REVISED PLANS FOR BUNGALOW ADJACENT TO MITTEN HILL FARM, HAWSKER.

PROJECT:
Bungalow adjacent to Mitten Hill Farm, Hawsker

TITLE: PROPOSED PLANS & ELEVATIONS

DRAWING No: D9393-04 REV: G

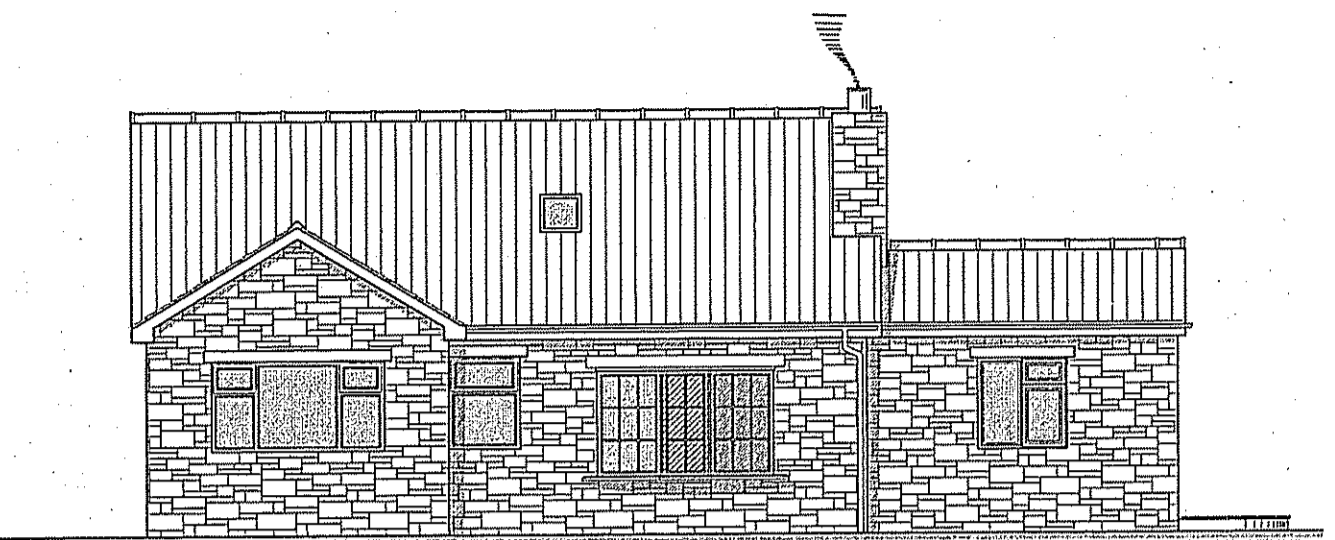
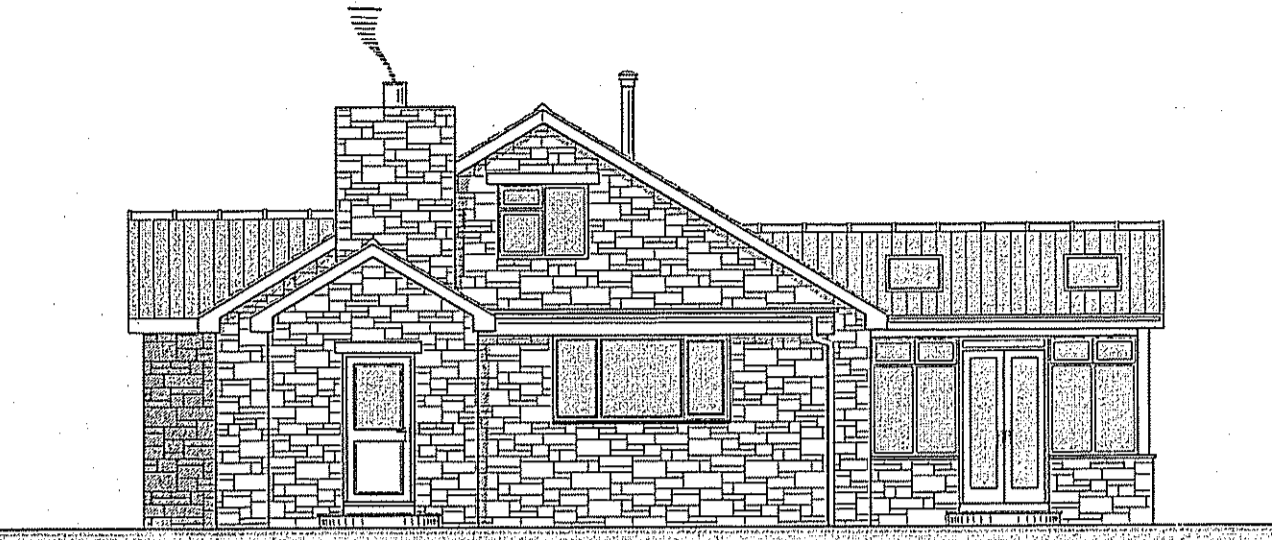
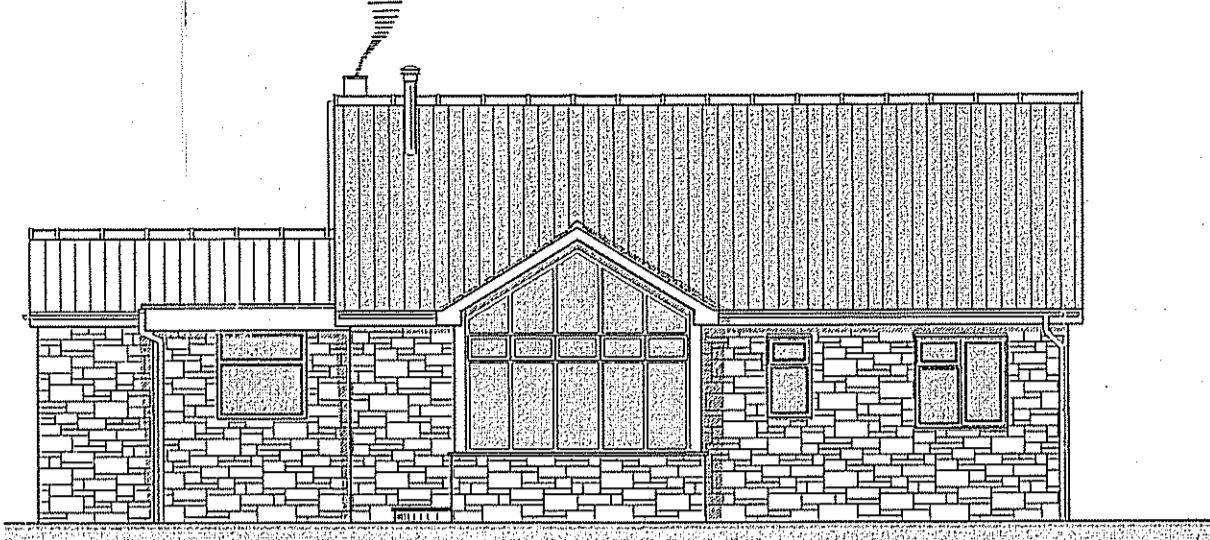
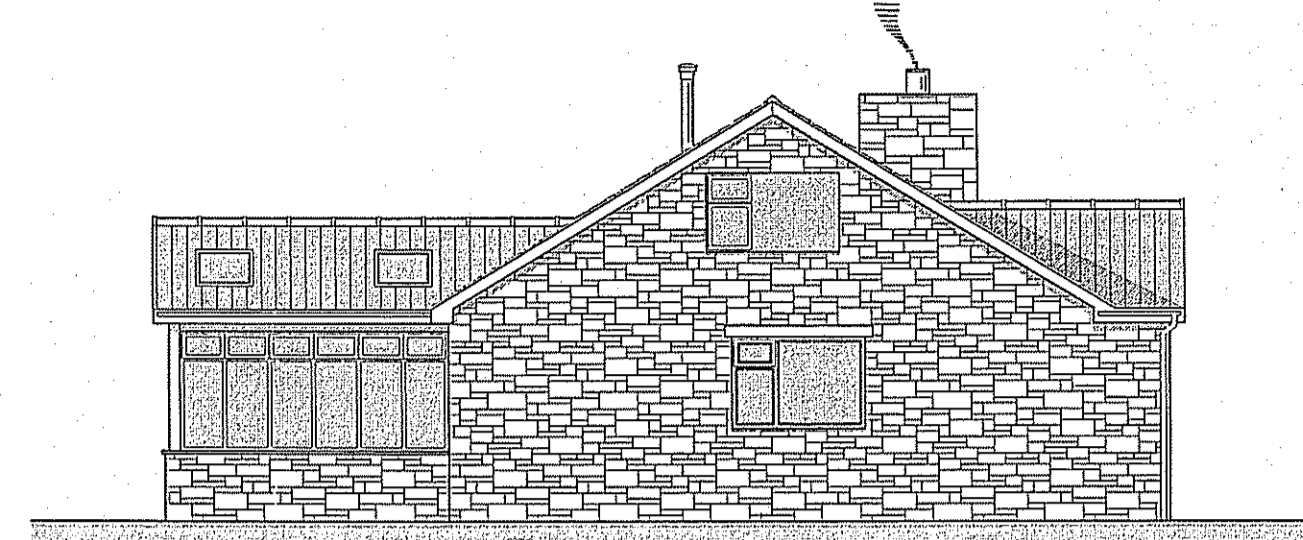
Please find attached drawings for the above project.
The drawings have been amended to show a pitched roof over the new extension which is 4.180m wide.

AMENDED
Notes
Flat roof replaced with pitch.
